INSPECTOR GENERAL

Compliance with Electrical and Fire Protection Standards of U.S. Controlled and Occupied Facilities in Afghanistan

Compliance with Electrical and Fire Protection Standards of U.S. Controlled and Occupied Facilities in Afghanistan

KAF-EL-120426-026
Figure 1. Reverse Polarity and No Grounding - Chaplain's Office Building Kitchen Area

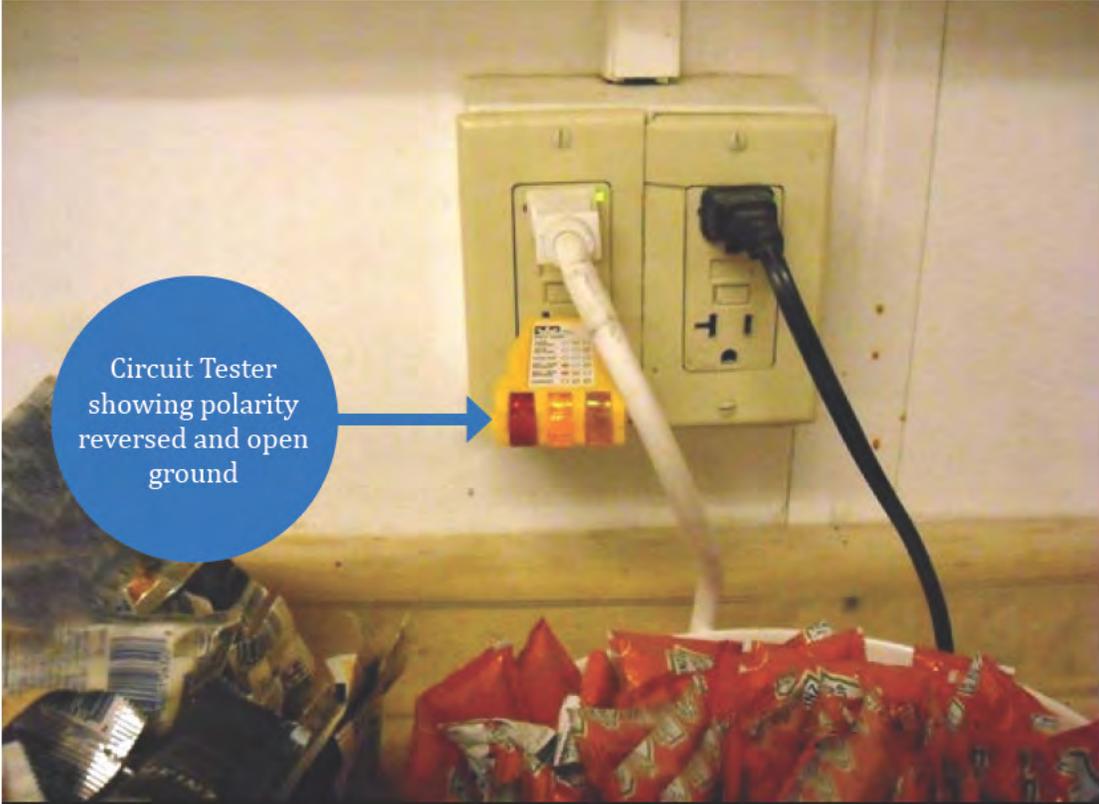
KAF-EL-120426-055
Figure 2. Noncontiguous Raceway in Outdoor Location

BAF-EL-120709-169
Figure 3. Unsecured and Unprotected Cables – Main Post Exchange

KAF-EL-120426-056B
Figure 4. Outdoor Hazardous Service Drops to Living Quarters

KAF-EL-120426-072 (left) KAF-EL-120426-087 (right)
Figure 5. Extension Cords Used as Permanent Wiring Run Through Doorways and Walls – Office Building

KAF-EL-120426-075
Figure 6. Hazardous Workmanship

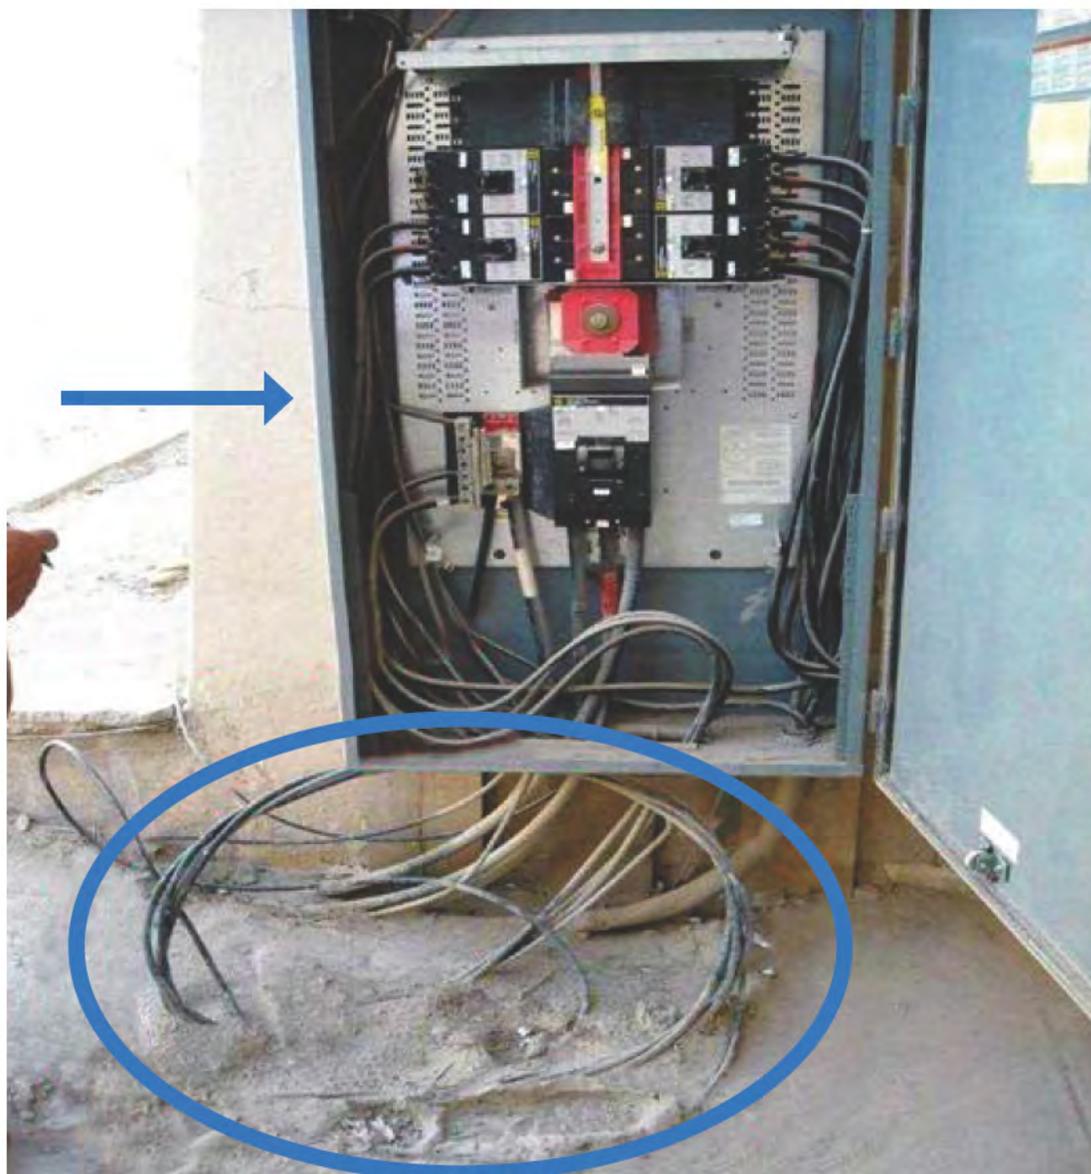
BAF-EL-120709-017 (left) BAF-EL-120709-063 (right)
Figure 7. Damaged and Hazardous Electrical Panels

KAF-EL-120426-084
Figure 8. Power Lines Run Across Roof of Living Quarters
